## Standards Subcommittee

**October 30, 2024, St. Louis, MO.**

#### **L.3.1 Standards Working Group on the Continuous Revision of C57.12.00**

#### **L.3.4 WG Standards Transformer on Continuous Revision for C57.12.90**

Figure 2—Induced-voltage test for Class II power transformers

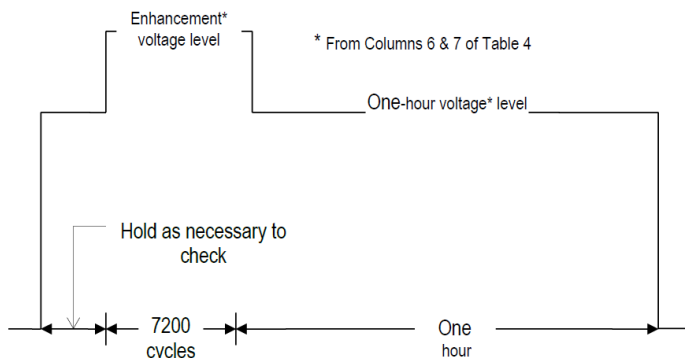
<sup>b</sup>~~The induced-voltage tests shall be conducted at voltages in the table above are based on an overvoltage factor of approximately 1.58 × nominal system voltage for the one hour test and 1.80 × nominal system voltage for the enhanced 7200 cycle test.~~

With the transformer connected and excited as it will be in service, an induced-voltage test shall be performed as indicated in Figure 2, at voltage levels indicated in Columns 6 and 7 of Table 4. ~~Minimum line-to-ground induced test levels for Class II power transformers shall be a multiple of corresponding line-to-ground nominal system voltage as follows: 1.58 times for one hour tests and 1.8 times for 7200 cycles enhancement level tests.~~

- Induced Overvoltage – Nominal versus Maximum operating voltage: Approved by TF and SC

Figure 2 —Induced-voltage test for Class II power transformers

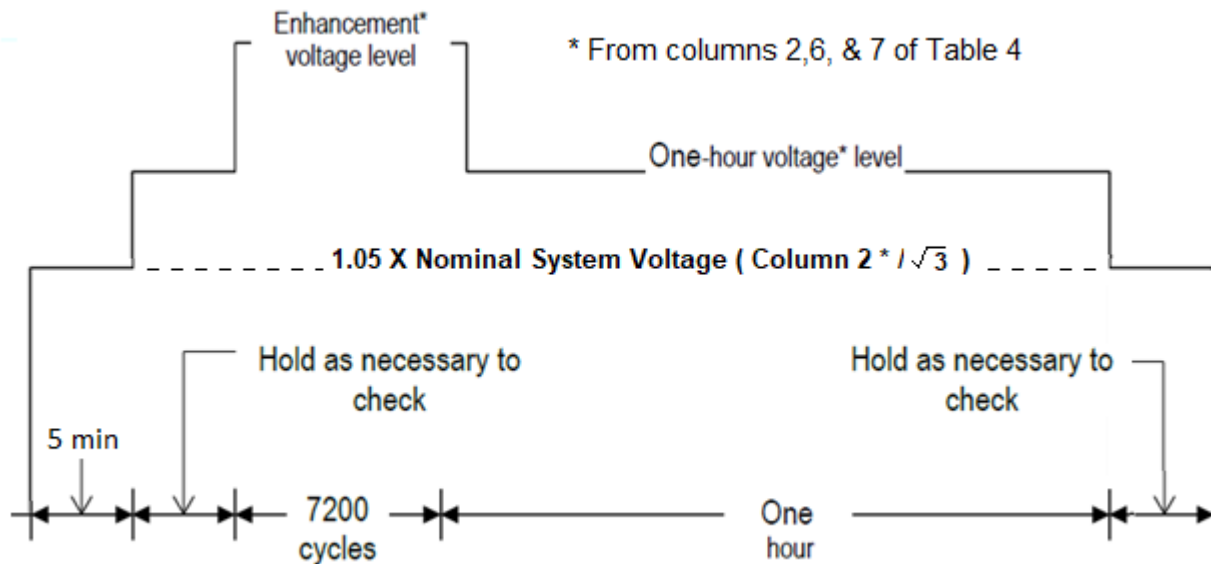
1. Changes to Low Frequency Tests from Ajith Varghese's RLFT TF in the Dielectric Test SC. The final survey approved by TF and SC in the Spring 2023 meeting is shown below. Text in black is existing, red is revised, blue is added.

With the transformer connected and excited as it will be in service, an induced-voltage test shall be performed as indicated in Figure 2, at voltage levels indicated in Columns 6 and 7 and **1.05 times the line to ground voltage per column 2 of Table 4**. Minimum line-to-ground induced test levels for Class II power transformers shall be a multiple of corresponding line-to-ground nominal system voltage as follows: 1.58 times for one-hour tests and 1.8 times for 7200 cycles enhancement level tests.

**Figure 1 —Phase relation of terminal designation for three-phase transformers**

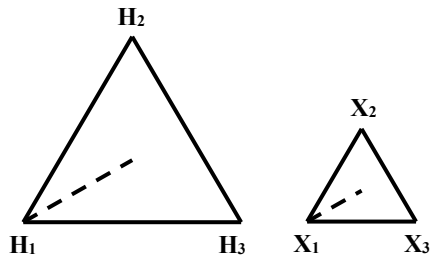
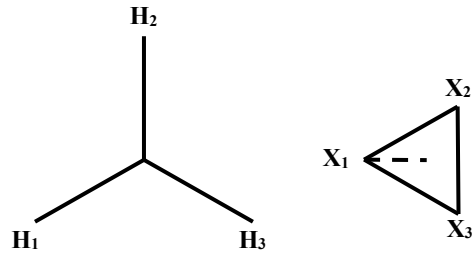
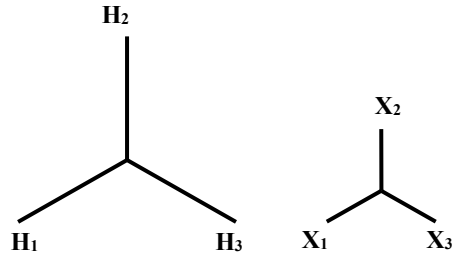
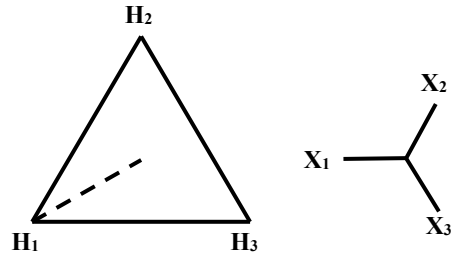
- Motion #2: Revise existing Figure 1 to describe the phasor group designation for the four example connections given, as: Dd0, Yd1, Yy0, Dy1
  - Motion #3: Revise Table 6, Row 11 for Nameplates A, B, and C. Change “Phasor Diagram” to “Phasor Diagram and Phasor Group Designation”

- Three motions passed:
  - Motion #1: Add the following sentence at the end of the second paragraph in Subclause 5.7.2: “The phasor group designation (vector group) shall be shown on the transformer’s nameplate, near the phasor diagram.”
